HAN1100 Ultimate Addendum

It has come to our attention that two measurements listed in the Ultimate manual are incorrect. This addendum corrects this issue by providing the correct measurements for the axle location on the wheel pant and the centerline on the firewall.

Page 56, Step 2

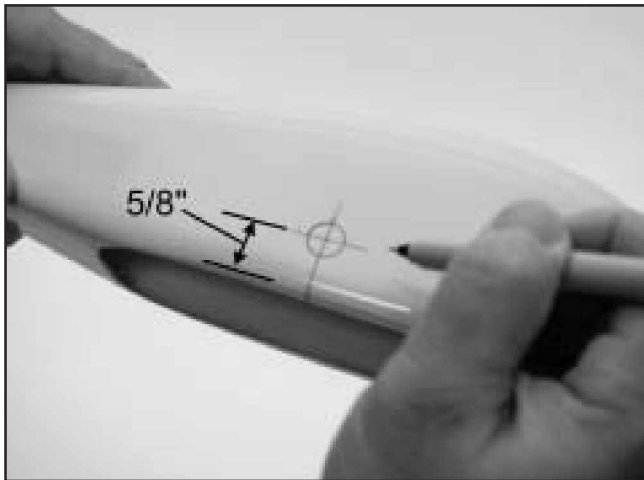
The photo for drawing the centerline on the firewall has the measurement referenced from the wrong side of the engine box. The correct wording and photo are as follows:

Draw a vertical and horizontal centerline on the firewall. The horizontal line is located $2\frac{1}{2}$ " from the top of the firewall, and the vertical line $3\frac{13}{16}$ " from the left side of the firewall, as viewed from the front.
